SCHEDULE OF AMENDMENTS:

PROJECT
28 Lockwood avenue,
BELROSE
NSW 2085

DATE	AUG 2024	NORTH
DRAWN	JS	CHECK NL
SCALE	1:200 @A1 Sheet Size	
DWG NO.	DA-101	ISSUE 5
STATUS	ISSUE FOR SECTION 4.55	JOB NO.

DRAWING
Basement 02 plan

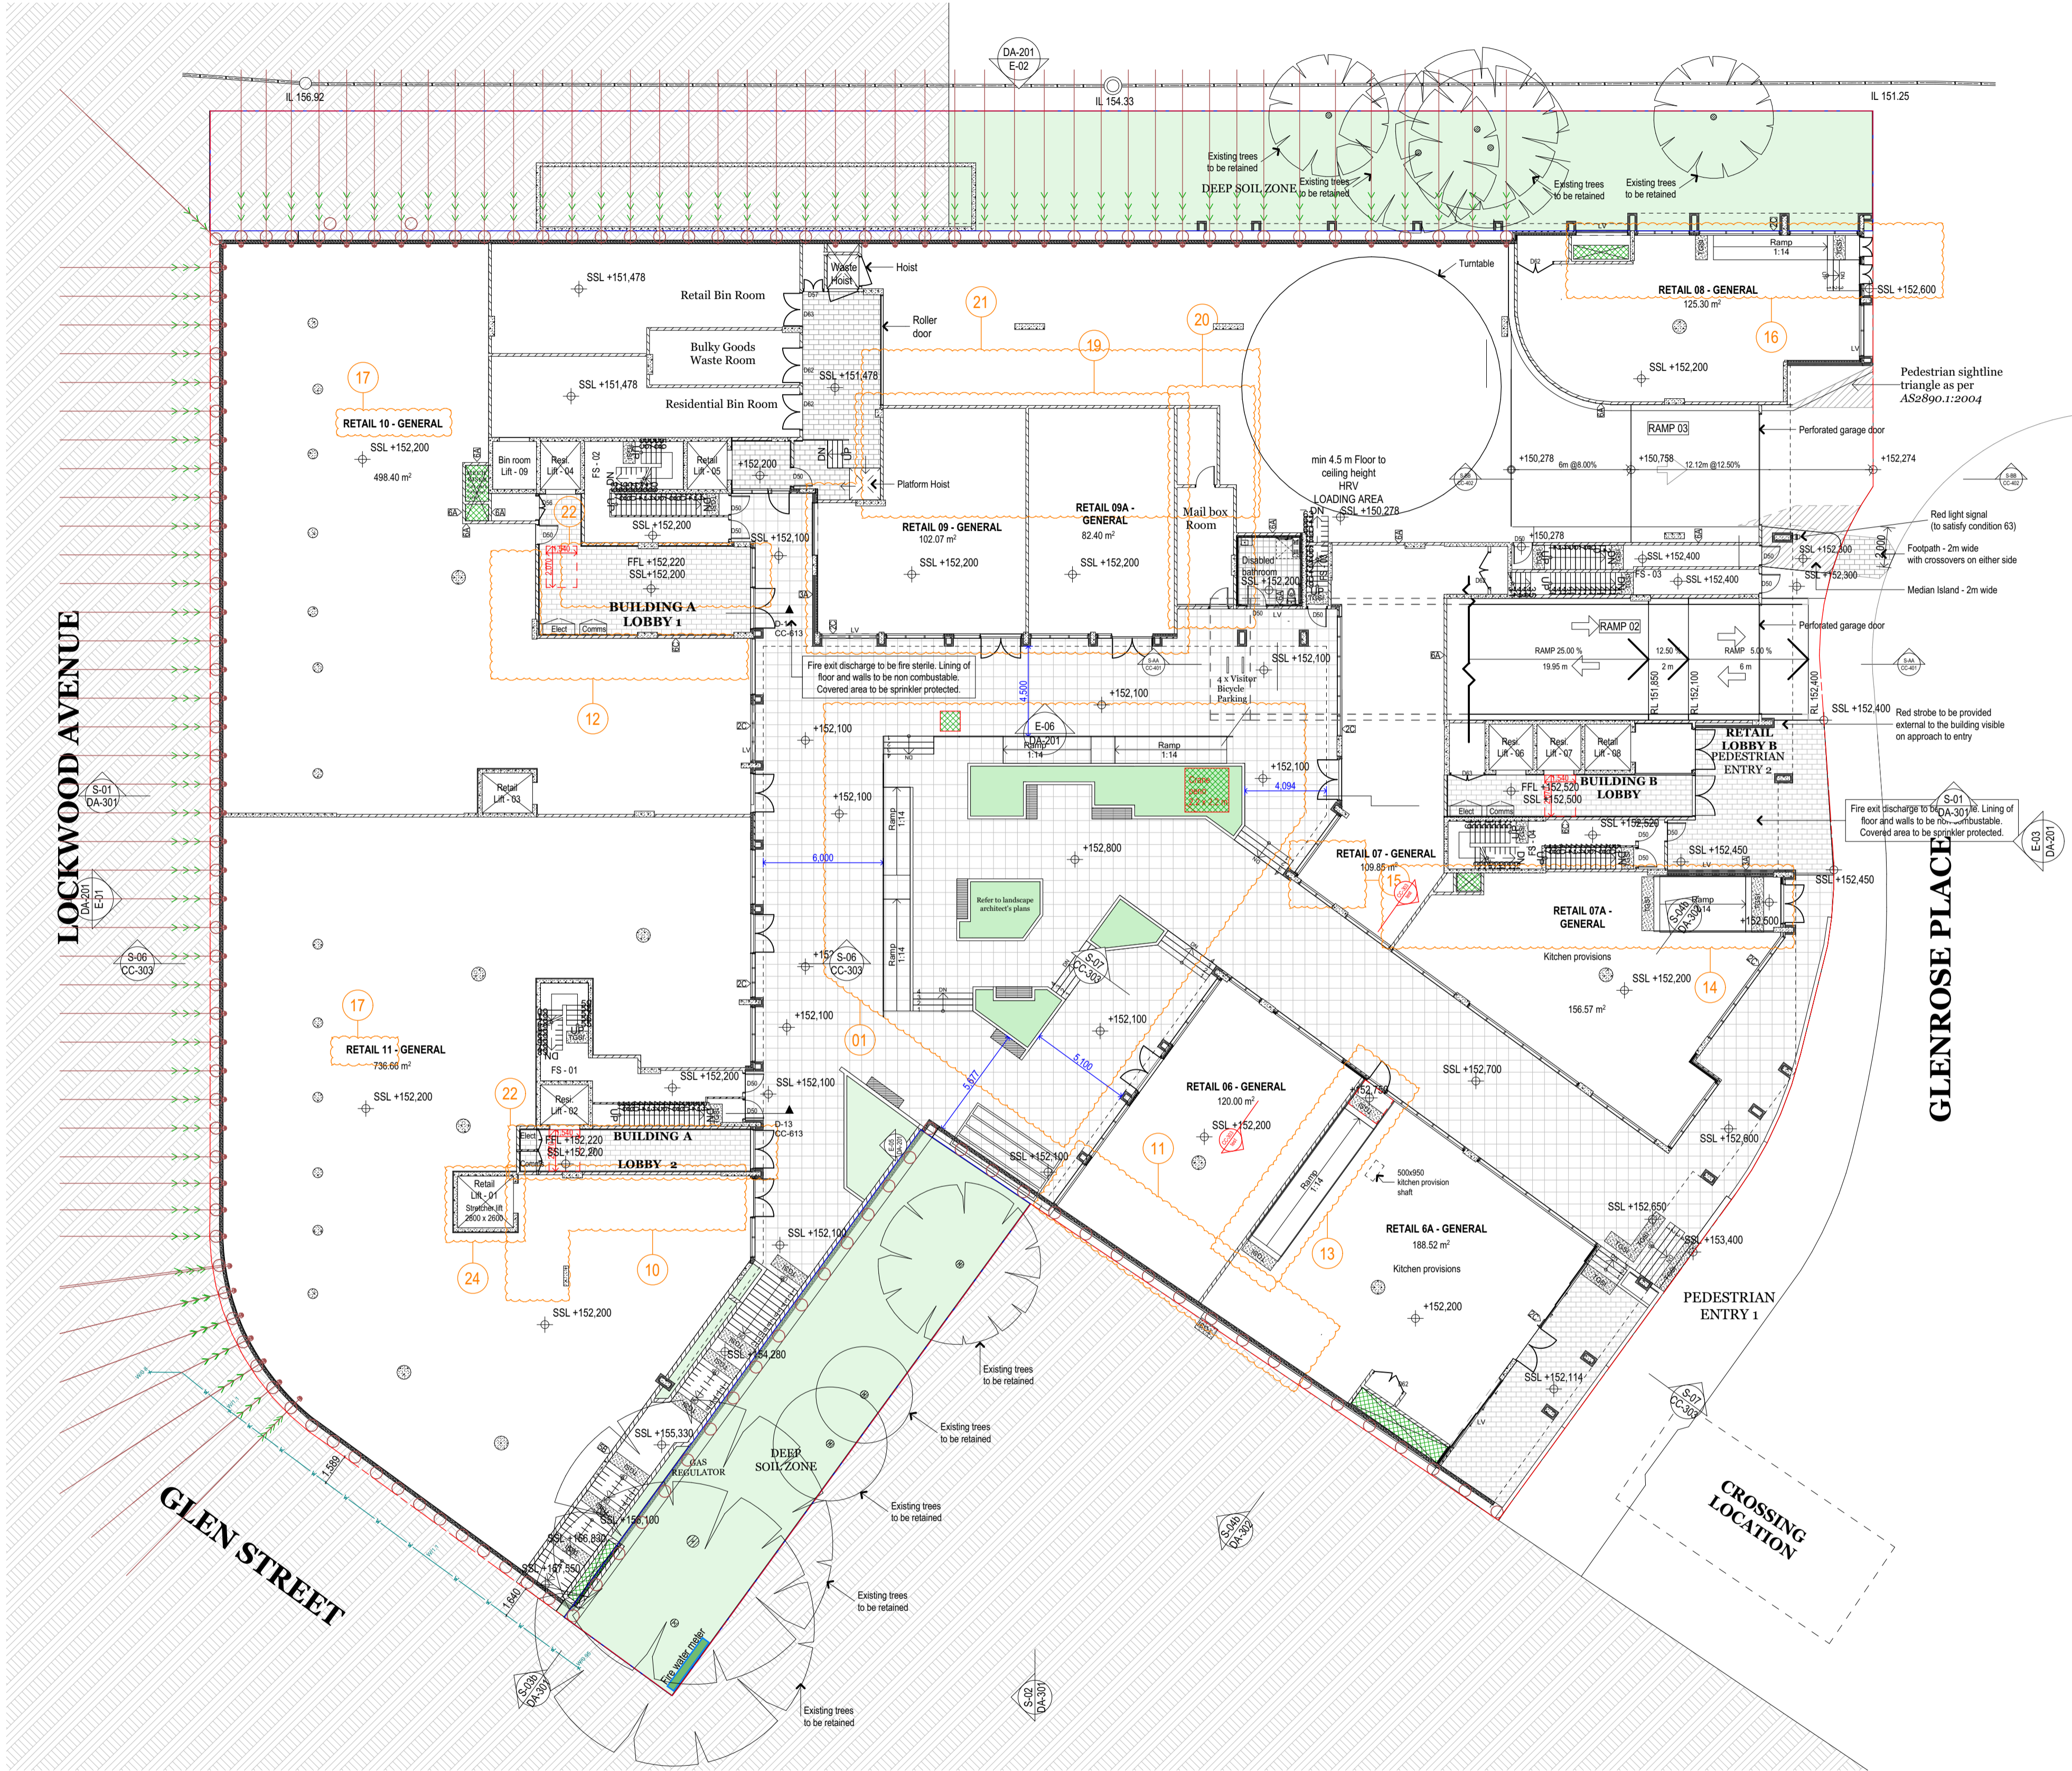
- 17- Retail 03 has been split into 3 retails across the three levels: retail 03 on ground floor, retail 12 on lower ground floor and retail 10 on basement 02 floor.

- Retail 05 has also been split into 3 retails across the three levels: retail 05 on ground floor, retail 13 on lower ground floor and retail 11 on basement 02 floor.

DRAWING
Roof plan

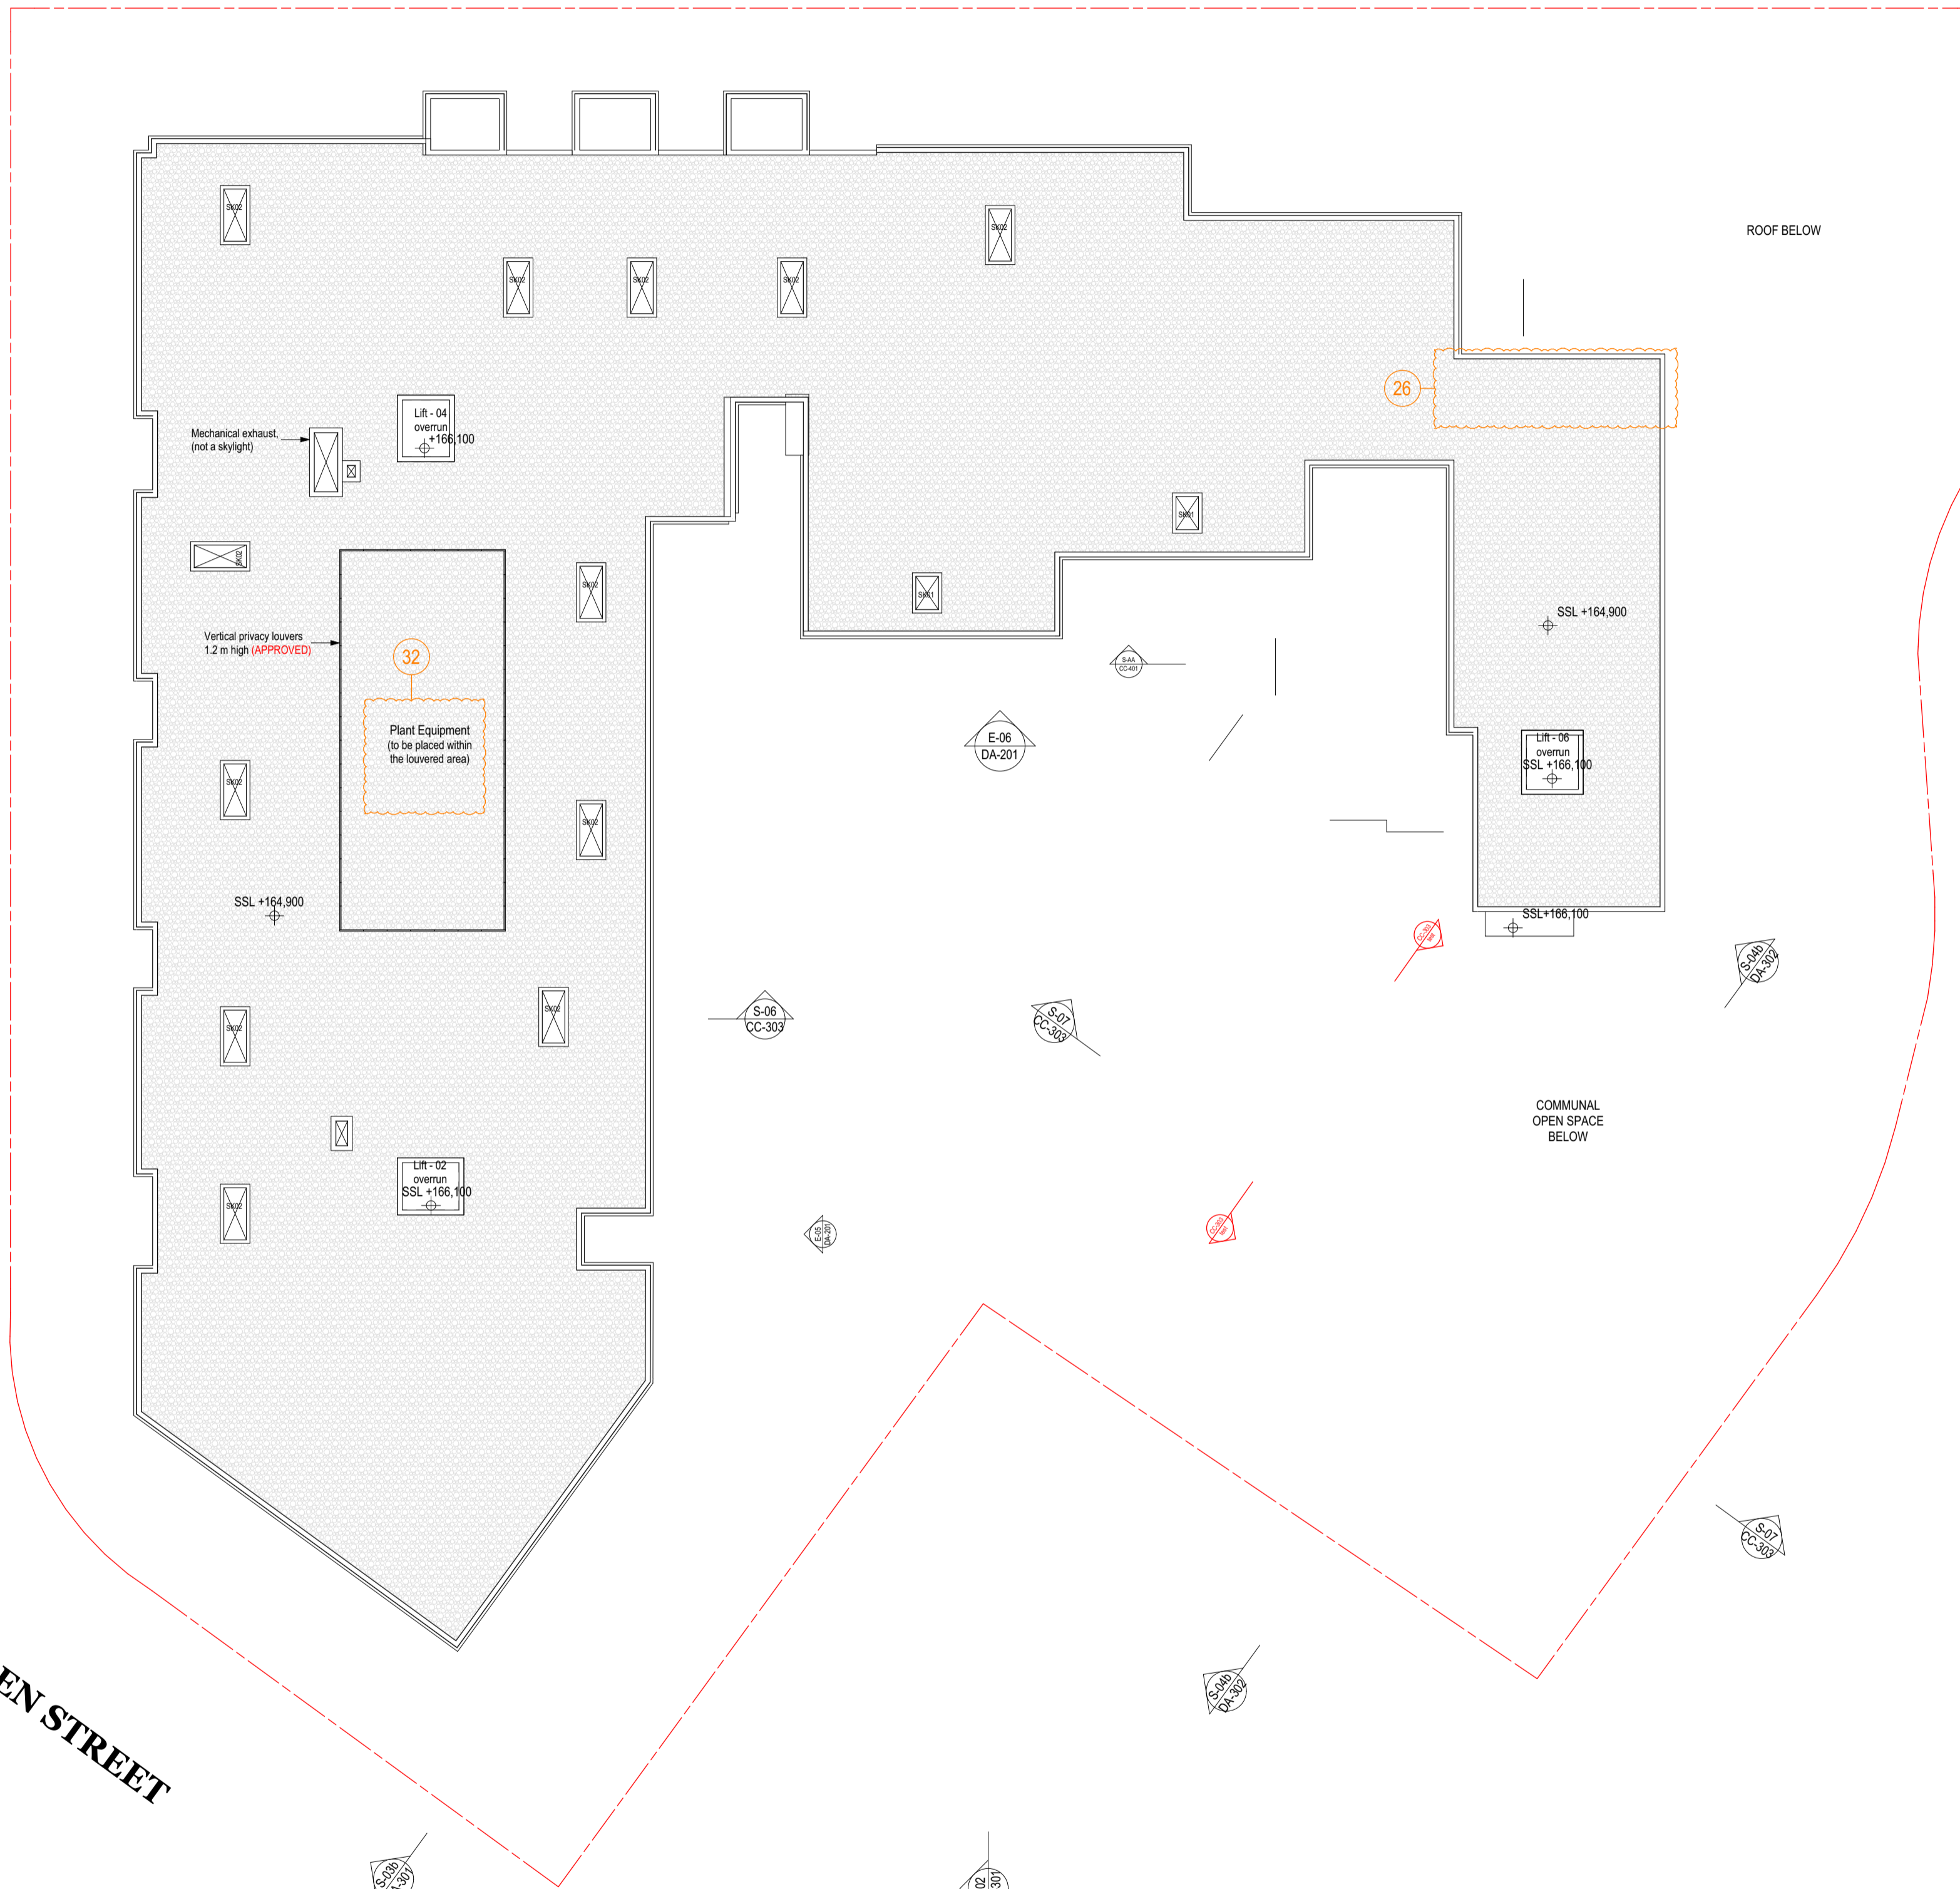
- 31- Two retail car spaces have been added on basement 04.
- 32- The plant equipments to be placed within the approved vertical louvered space on the roof.
